# **SECTION 4.55(1A) MODIFICATION STATEMENT**

SSD 10285 - Leger Lawn,  
Royal Randwick Racecourse

Figure 1 Comparison of approved and proposed North Elevation (laneway-side)

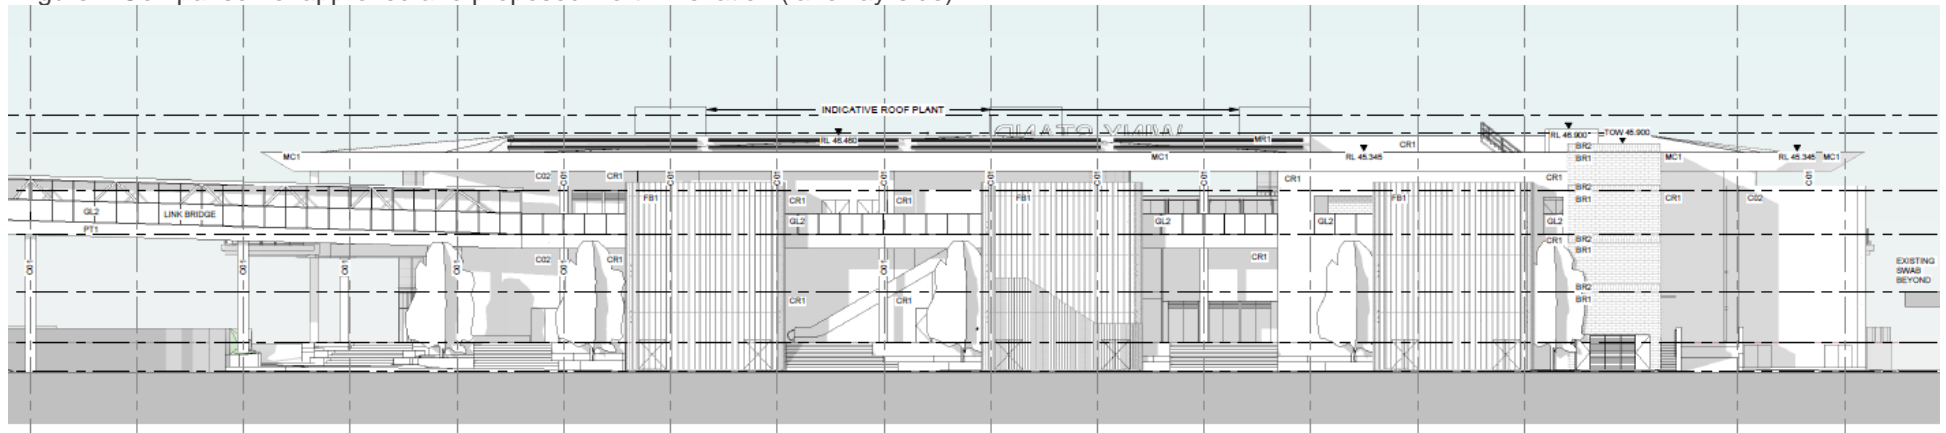
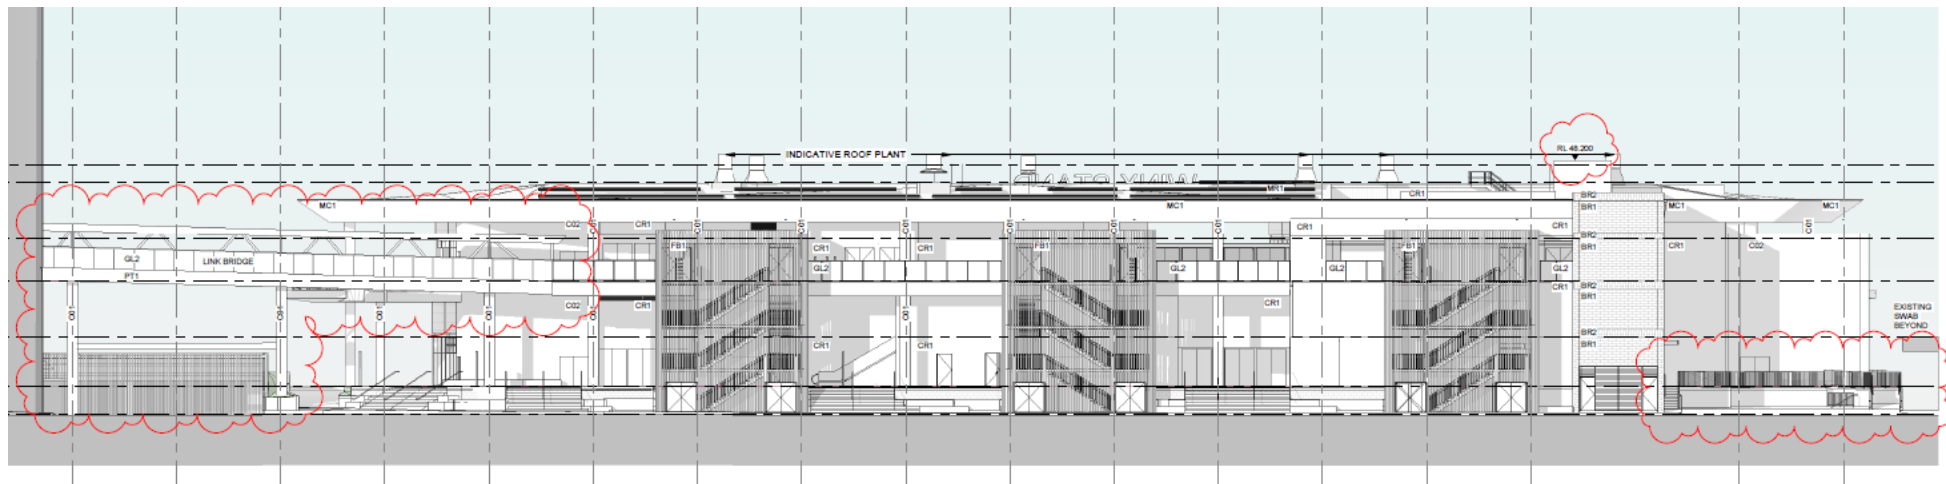
- Provision of a new external roof structure above the existing QE II loading dock on the eastern elevation of the Winx Stand.
- Provision of a concrete access ramp adjacent to the ground floor loading zone on the western elevation,
- Minor internal floor plan amendments to improve functionality.
- Provision of an external bar on the Level 1 terrace (track-side).
- Minor revision to the location of the QE II Stand link bridge to enhance connectivity.
- Revision to the materiality of the western façade from 'light grey' cement render to 'urban grey' fibre cement sheeting.
- Minor increase to the lift overrun.

These amendments are detailed (and clouded for ease of reference) in the Architectural Plans prepared by Cox provided at **Appendix A**. A comparison of the approved and modified elevations illustrating the proposed refinements are also provided below.

Figure 2 Comparison of approved and proposed East Elevation

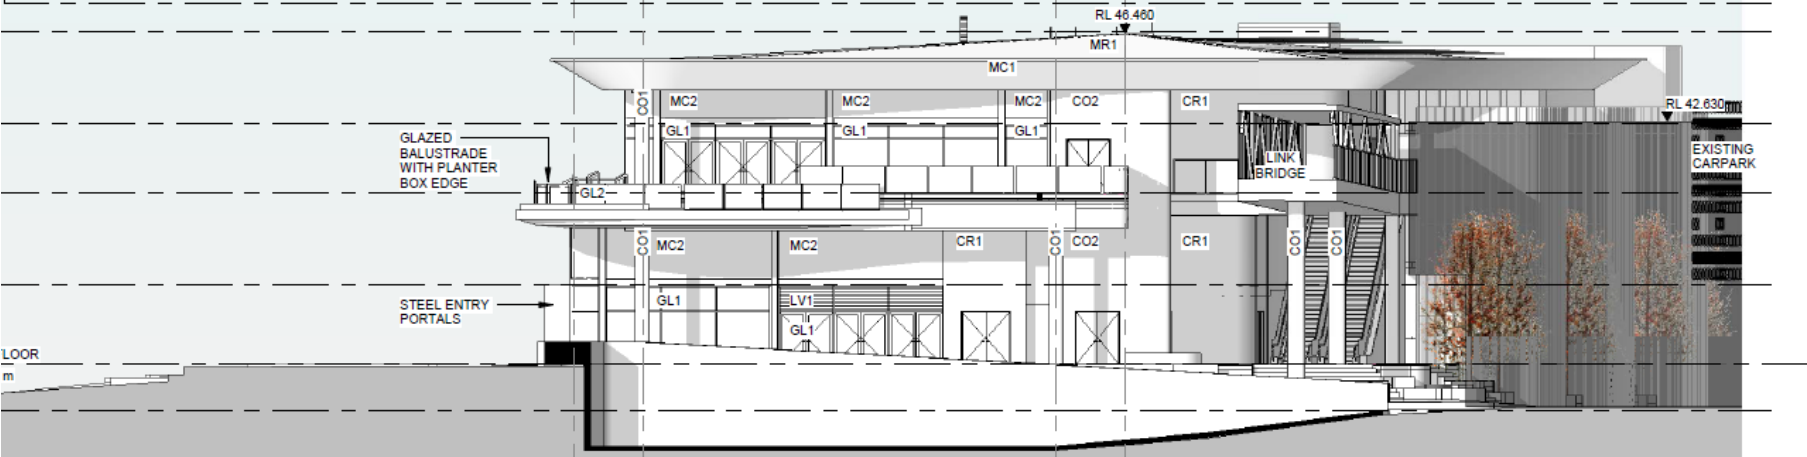
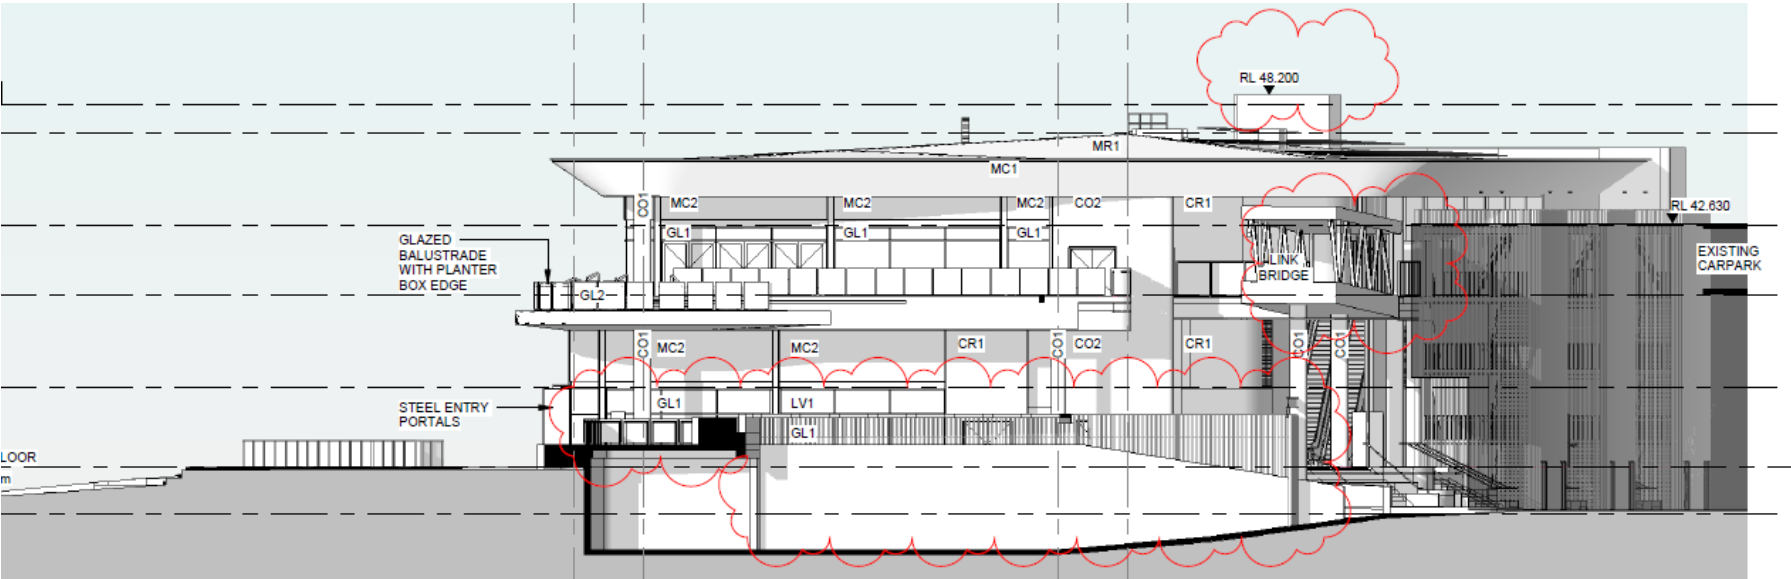
- The proposal will improve the servicing of the Winx Stand through the additions to the Winx Stand loading dock and existing QE II loading dock. The proposed roof structure will provide all-weather shelter and protection for employees of the site, consistent in materiality to the approved Winx Stand. The roof structure will also improve the aesthetics of the existing loading dock that will be overlooked by the Winx Stand and QEII Grandstand and enable back-of-house operations to be hidden from view of patrons.

Figure 3 Comparison of approved and proposed South Elevation (track side)

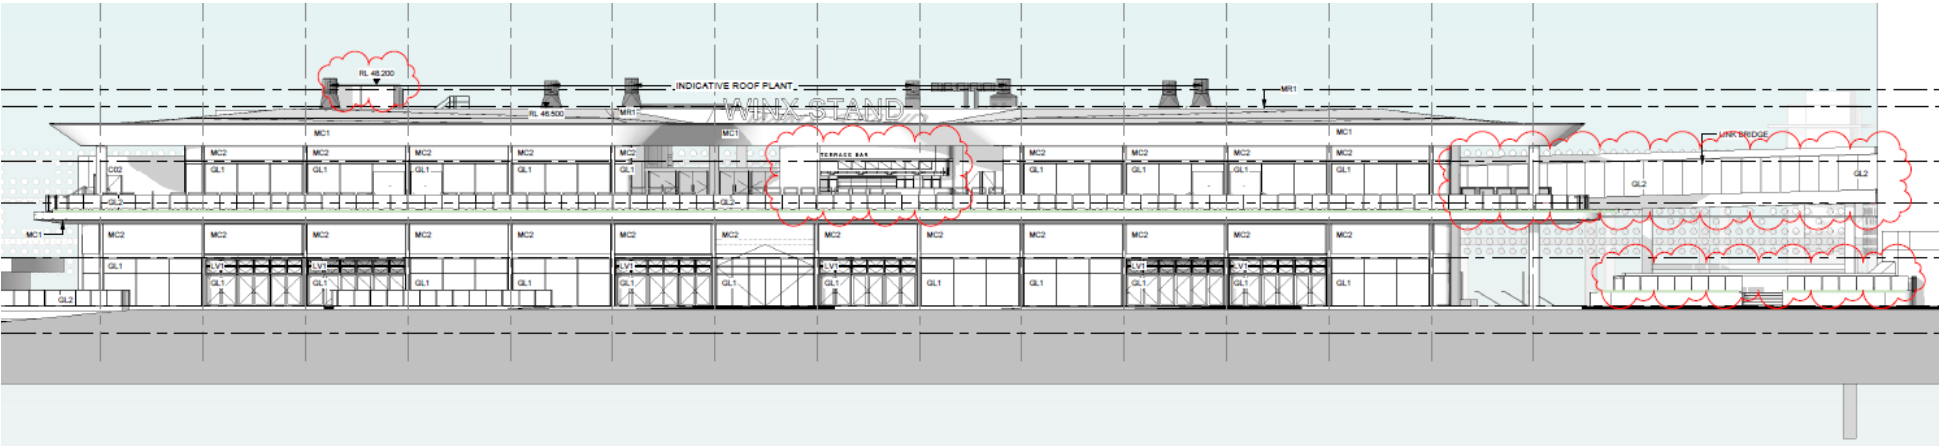
- The proposed ramp access will improve OH&S operations and functionality for employees loading and unloading goods to the Winx Stand.
- The conversion of an approved food serving bar on the external Level 1 terrace (track-side) to an external drinks bar will further activate the terrace area and improve functionality and service for patrons viewing events from the terrace. This proposal will not result in increased GFA and will comply with the Operational Noise and Vibration Management Plan approved under SSDA 10285.

Figure 4 Comparison of approved and proposed West Elevation

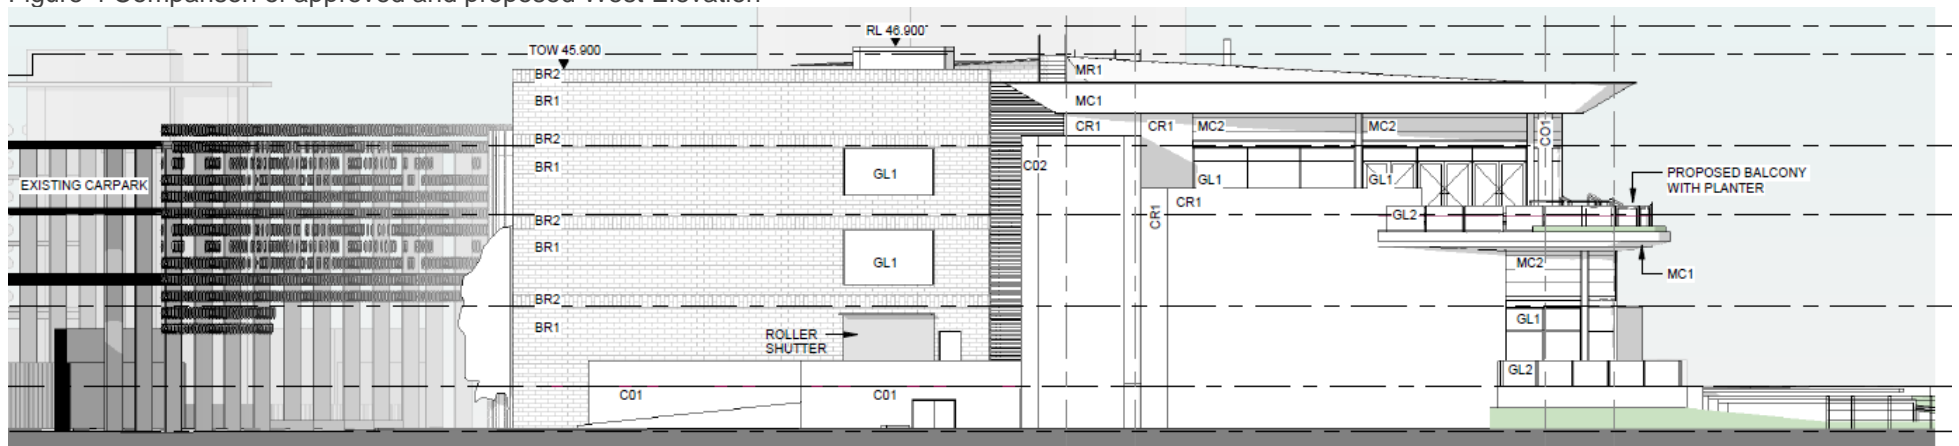
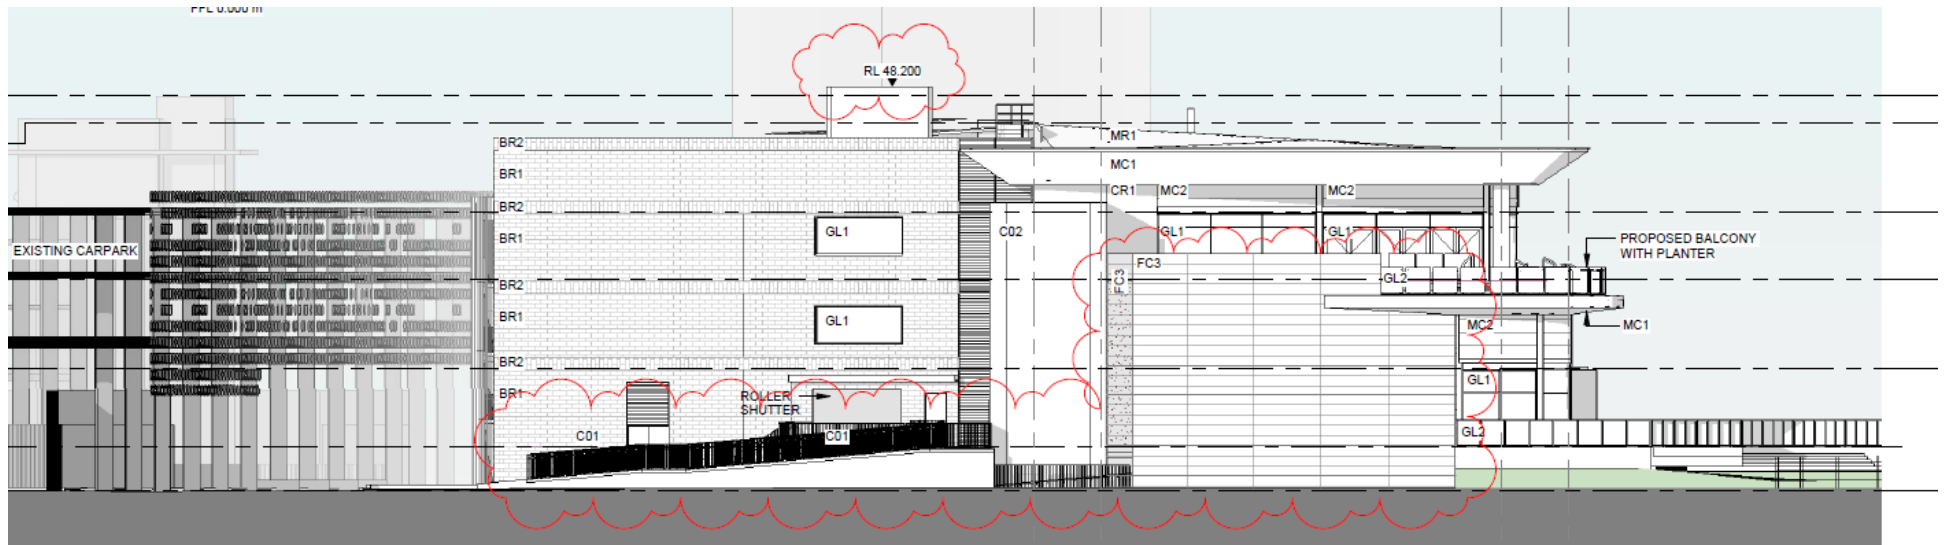
- The revision to the materiality of the western façade will improve the durability of the façade, noting that this façade is located adjacent to the existing swab building and will not be visible from the public domain.

Figure 5 Terrace Bar Design

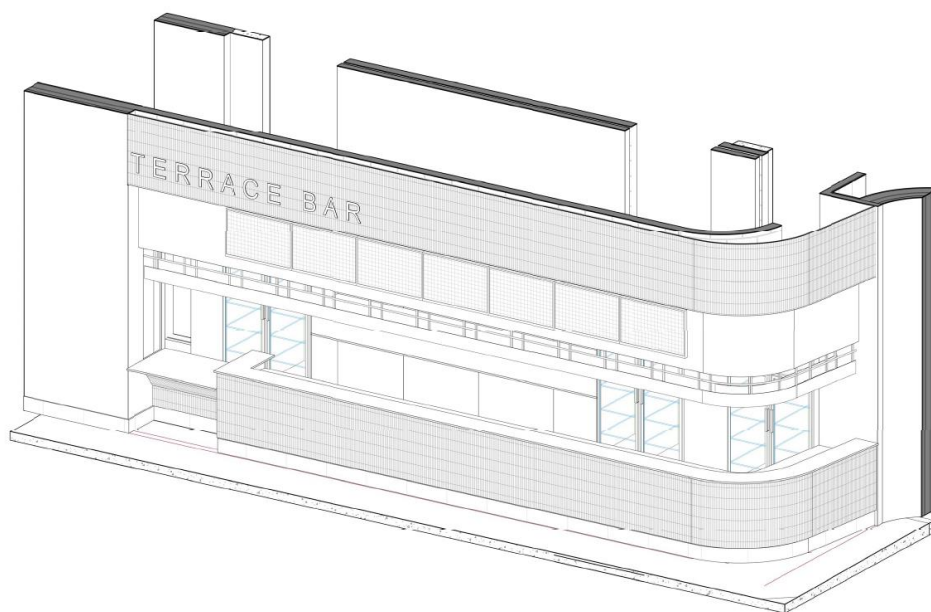
The introduction of a rooftop terrace bar on level 1 is consistent with the approved use and purpose of this space and demonstrates synergies with the adjacent front of house multi-purpose halls, interlinking open terrace and back of house servicing areas. As illustrated in Architectural Plan A-68-20, and identified in the extract below, the materiality and design concept of the terrace bar is consistent with the approved design of the building and comprises a refined palette comprising a stone bar top and tiled bar façade, terrazzo skirting and LED strip lighting.

The bar is located adjacent to the level 1 kitchen and storage room to provide improved efficiencies in servicing and operation and will provide improved convenience and servicing for patrons located on the adjacent external terrace area. The bar will only be utilised to service functions and patrons associated with the race day and non-race day events and will not be available for broader public functions or as a public food and drinks premises.

Figure 6 Design development of the western façade

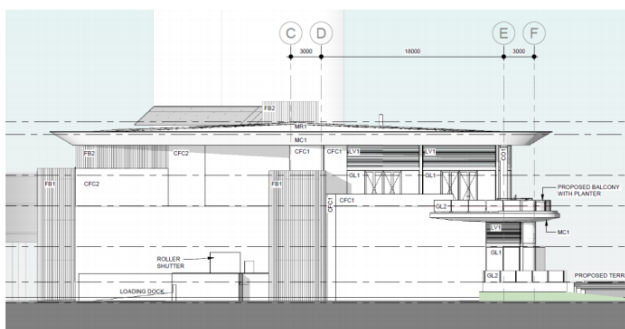
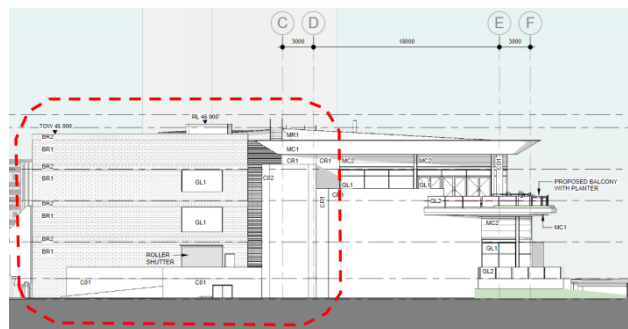
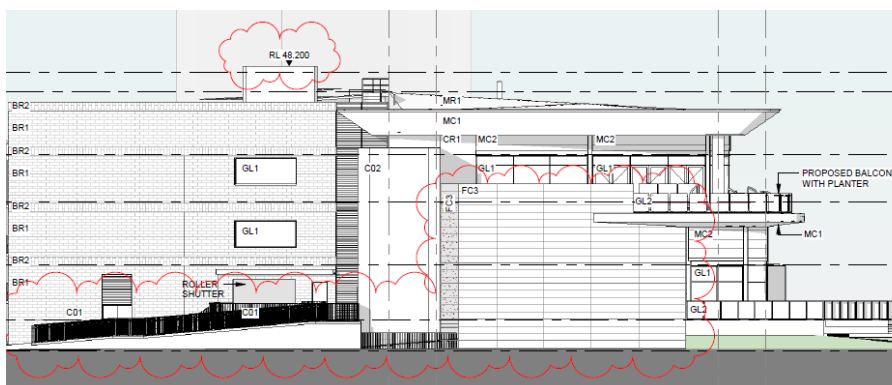
The revision to the materiality of the western façade from 'light grey' cement render to 'urban grey' fibre cement sheeting does not change design feedback provided by the GANSW on the western elevation articulation. As illustrated in **Figure 6**, upon recommendation from the GANSW the materiality of the northern-most portion of the western façade was amended to the (now approved) face brickwork. No changes are proposed to this portion of the elevation. As the southern-most portion of the western elevation is largely concealed by the existing Swab building, this modification will have a negligible visual impact and will not undermine the commentary received from GANSW.
